Placer County Office of Education

Office Building Tenant Improvements, Annex Building Alterations, & Site Improvements @ Various Sites

ADDENDUM NO. 2

Friday, September 1, 2023

1 PARTIAL ONE LINE POWER DIAGRAM

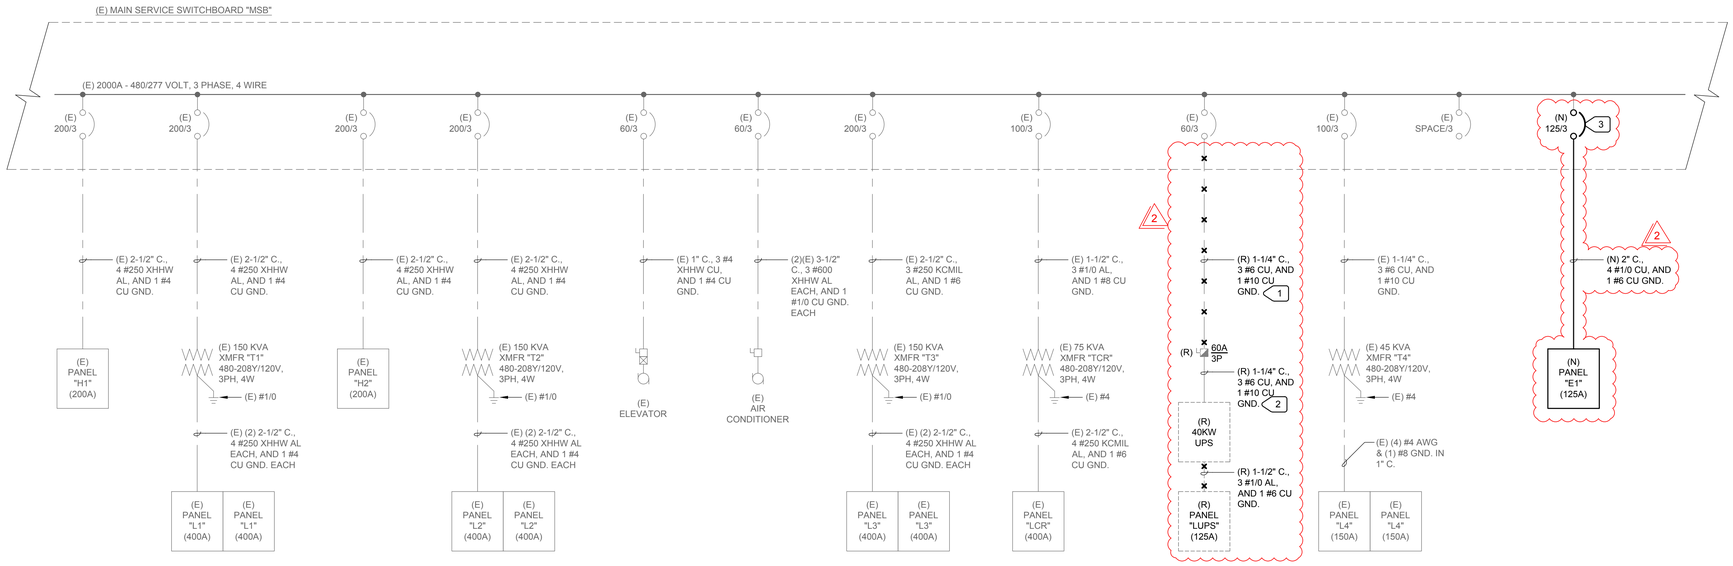
A. **REVISED** corresponding one-line diagram. **See attached 'SHEET E4.01'.**

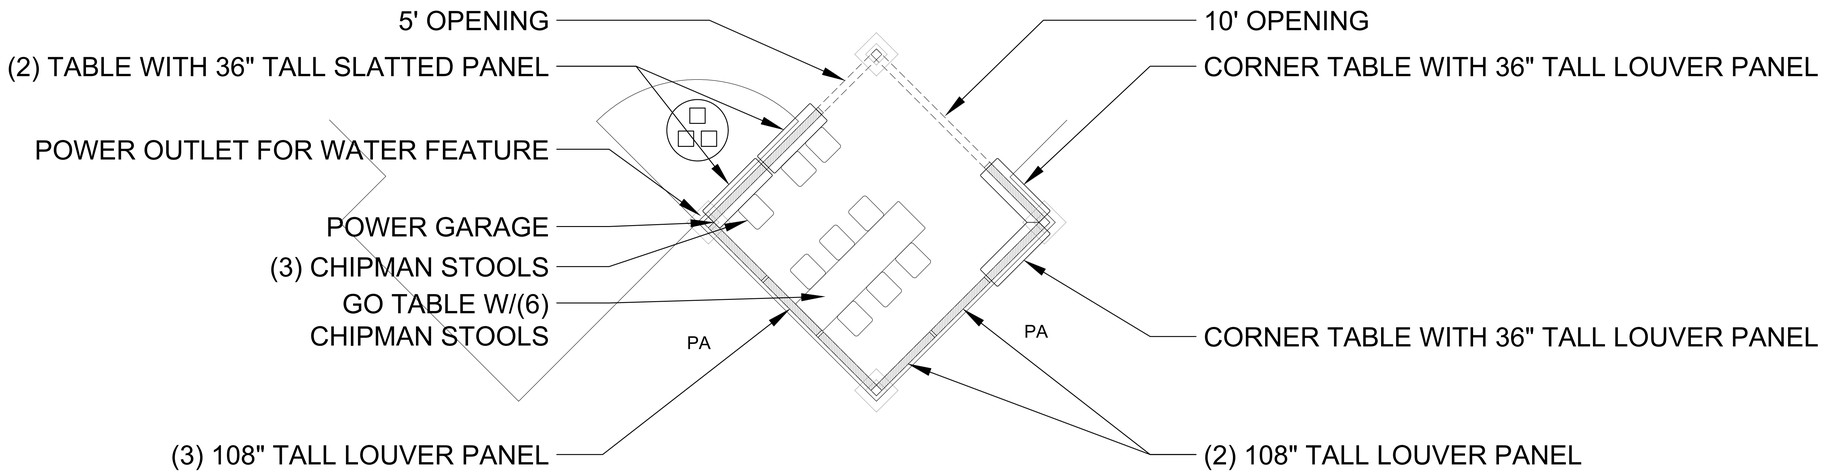
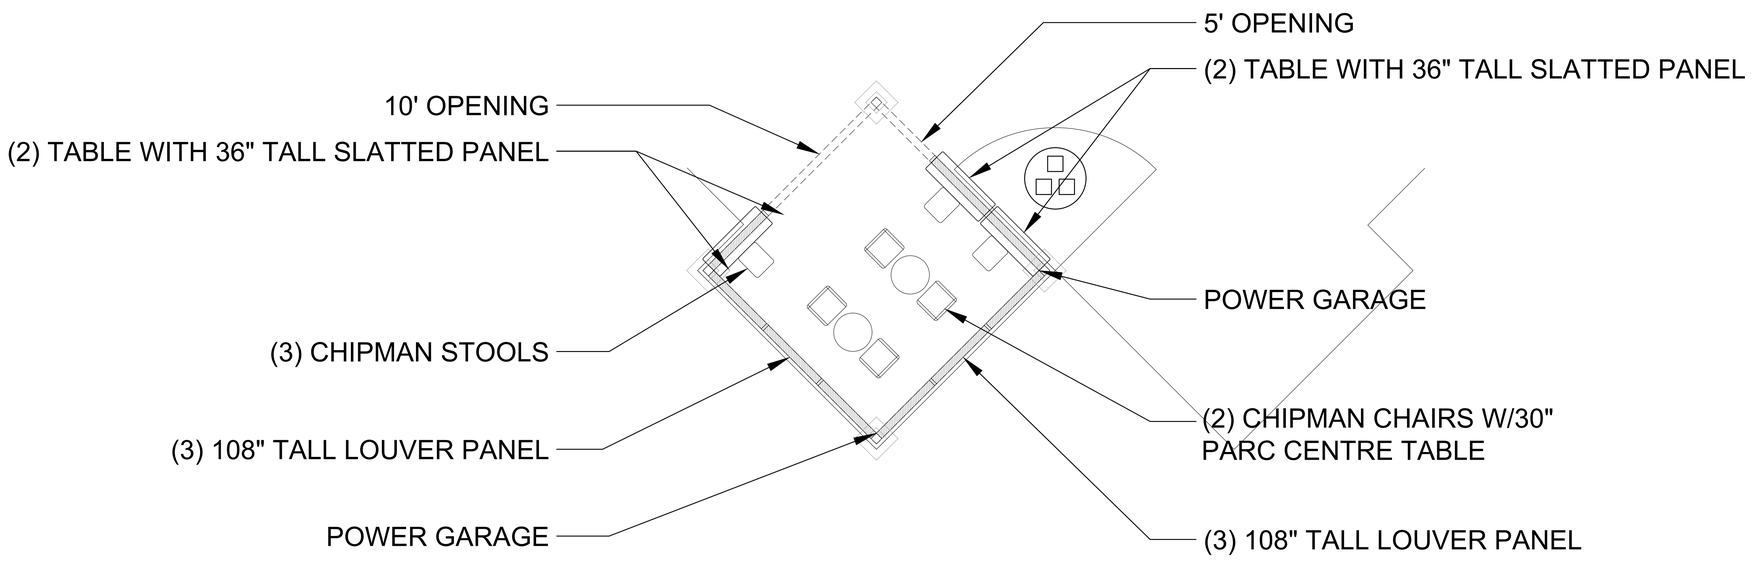
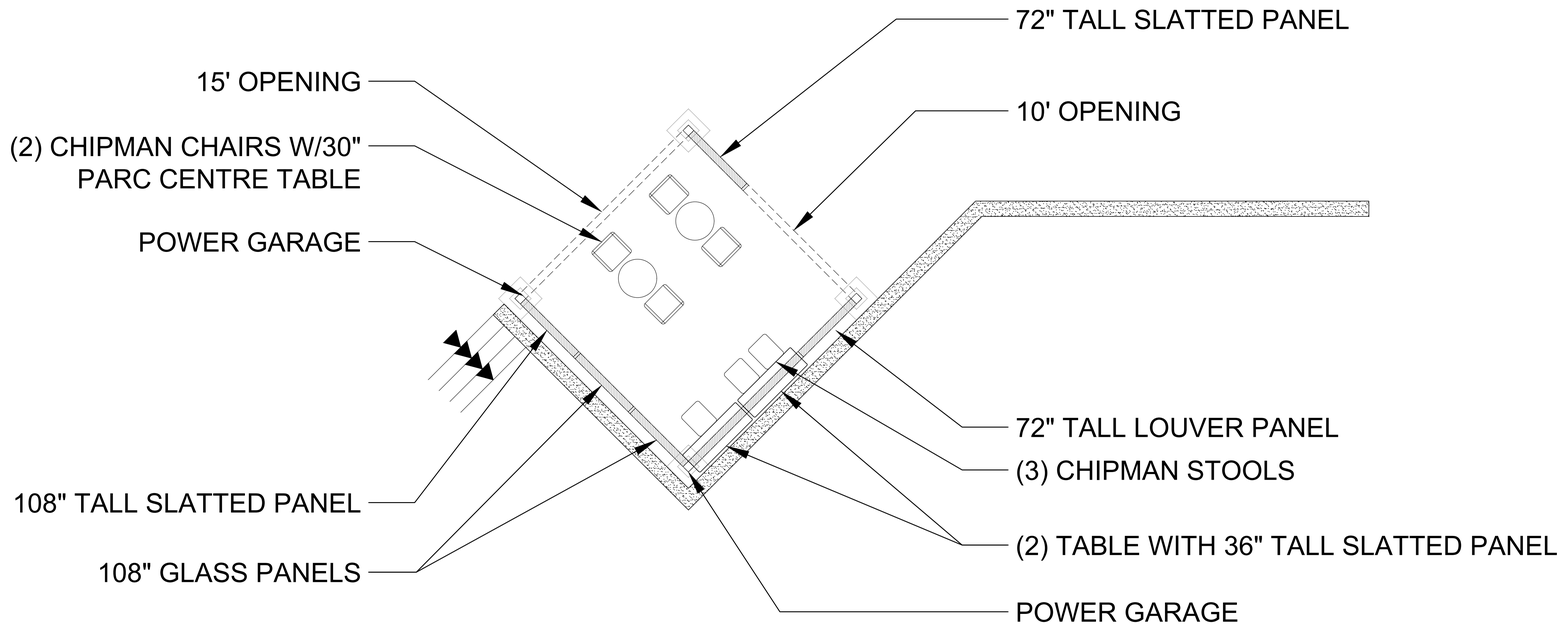
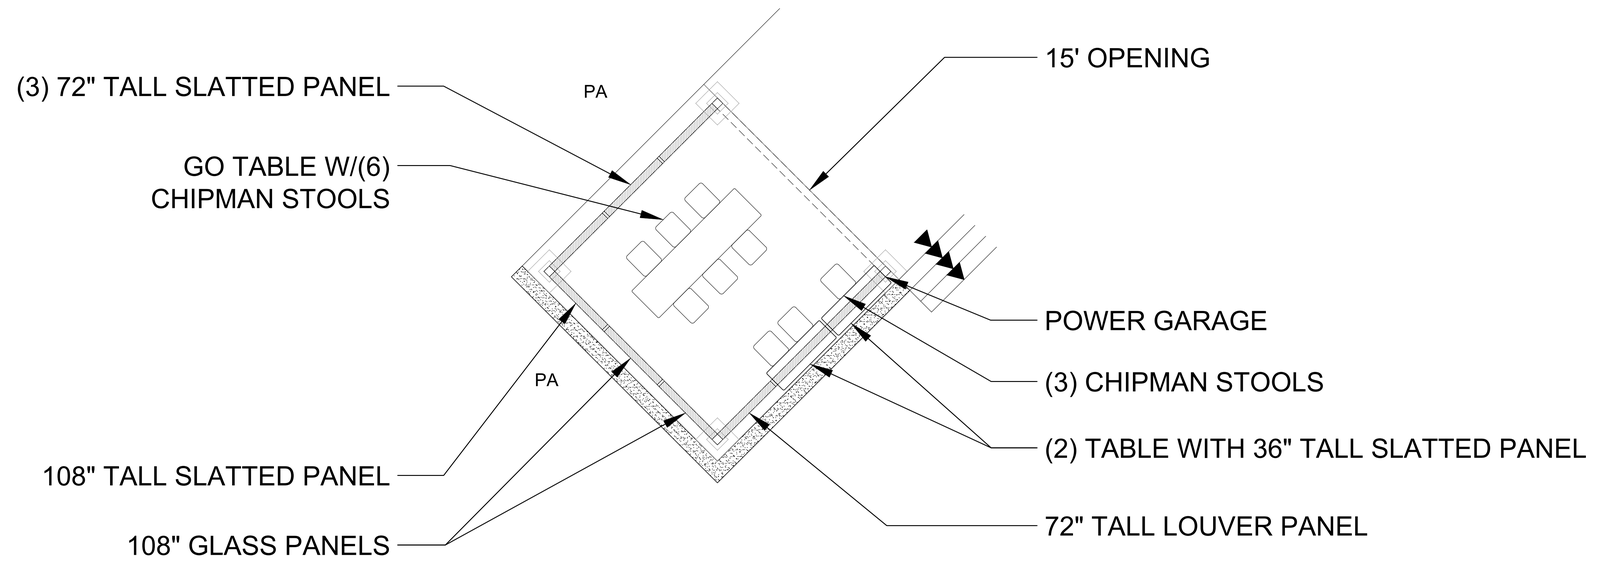
A. **ADD** sheet in its entirety for outdoor structure layout. **See attached 'SHEET L0.2'.**
B. **CLARIFICATION.** New structure shall be OFOI. Contractor to provide footings and coordinate installation with Owner.

1 / E1.01 PARTIAL SITE PLAN - ELECTRICAL

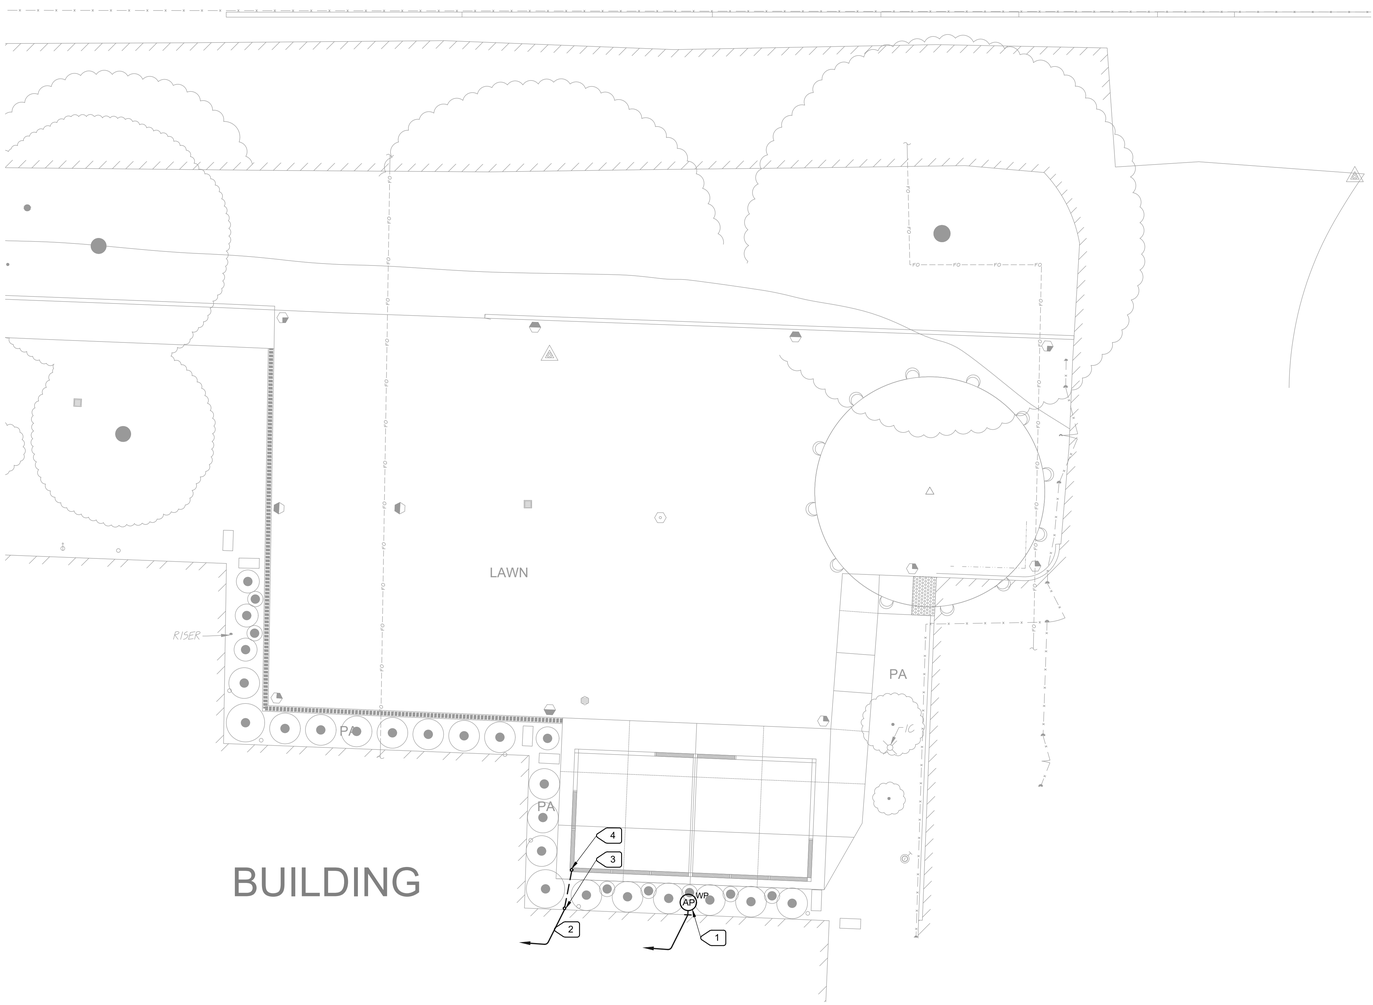
A. **ADD** sheet in its entirety. **See attached 'SHEET E1.01'.**

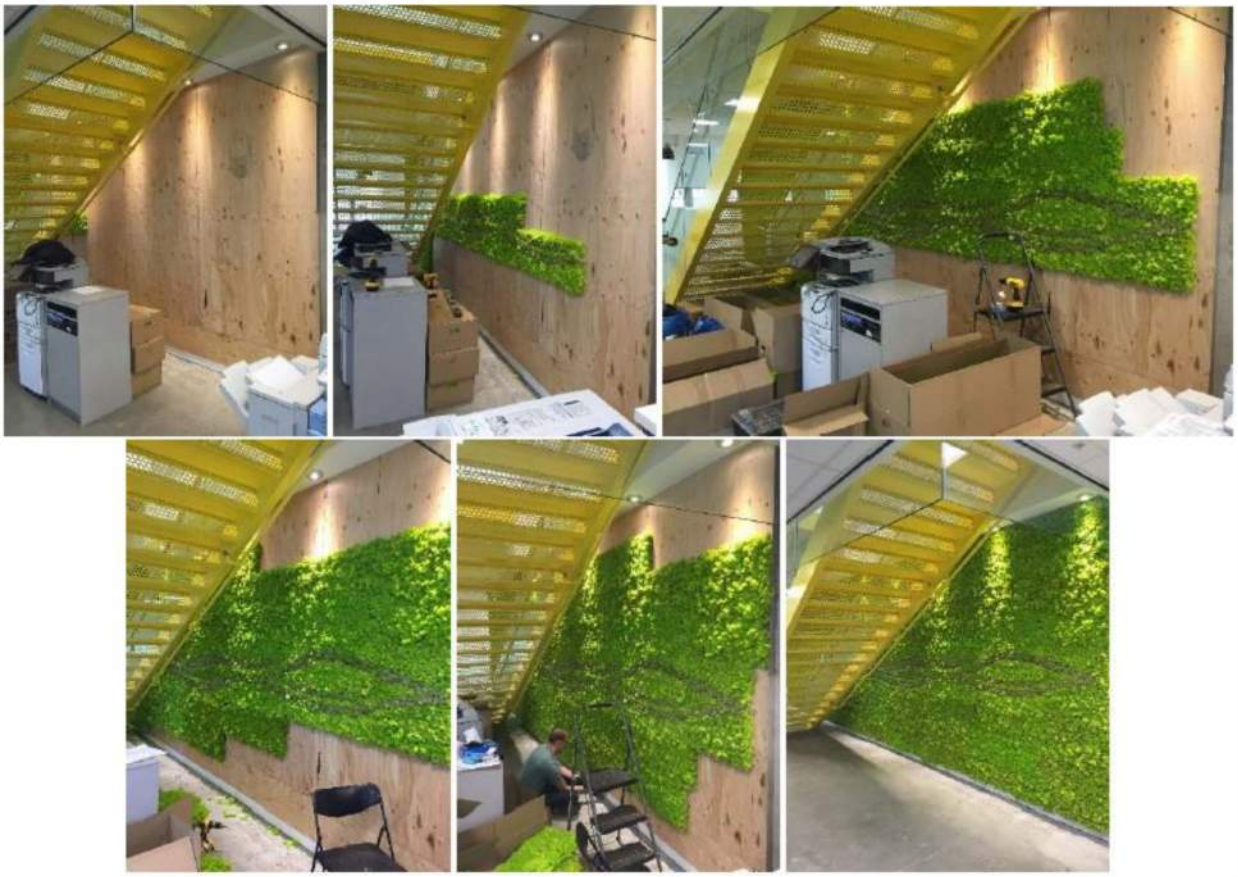
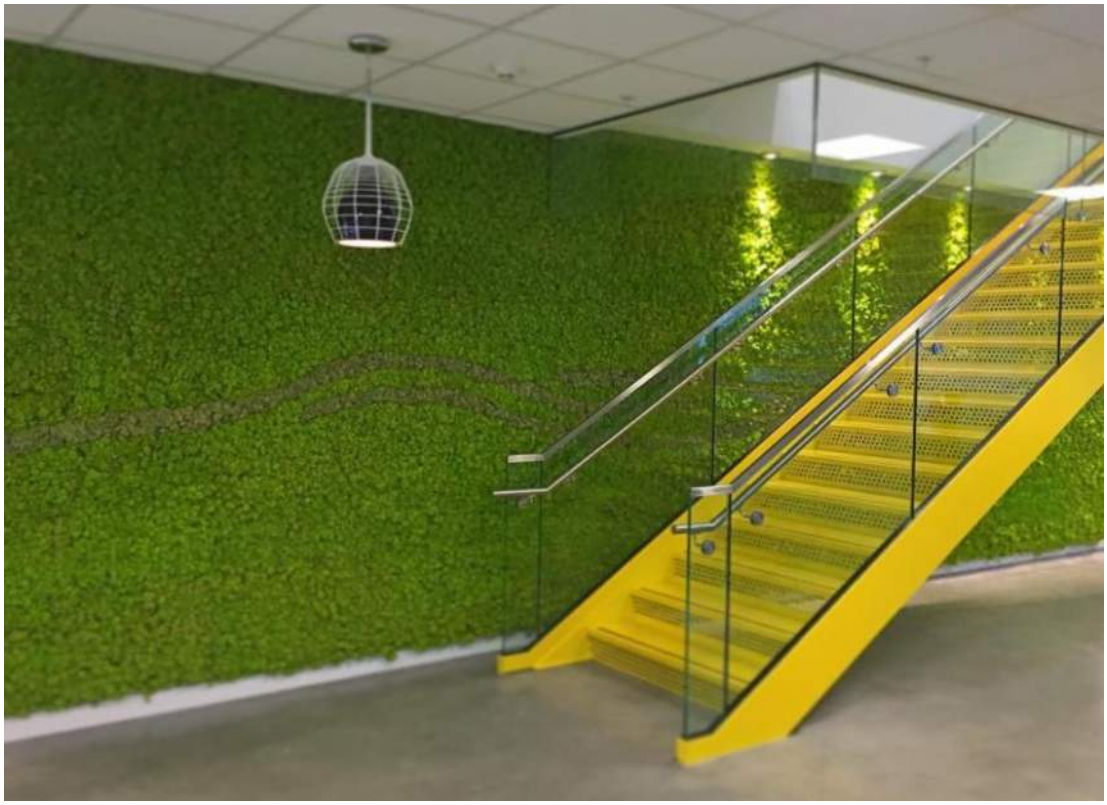
30. *Keynote 12.03 on A2.06 indicates "moss walls" to be provided. No detail or specification is given for these items. Please provide the following:*
    a. *Confirm if this is an contractor furnished and installed item. Is just providing the backing required or is the contractor providing and installing the item?*

Response:
a. Product specification does not exist. Product shall be OFCI.
b. Refer to MFR installation guideline attached.
c. Refer to detail 25/A9.02 in Addendum No.2 for furred wall and niche.
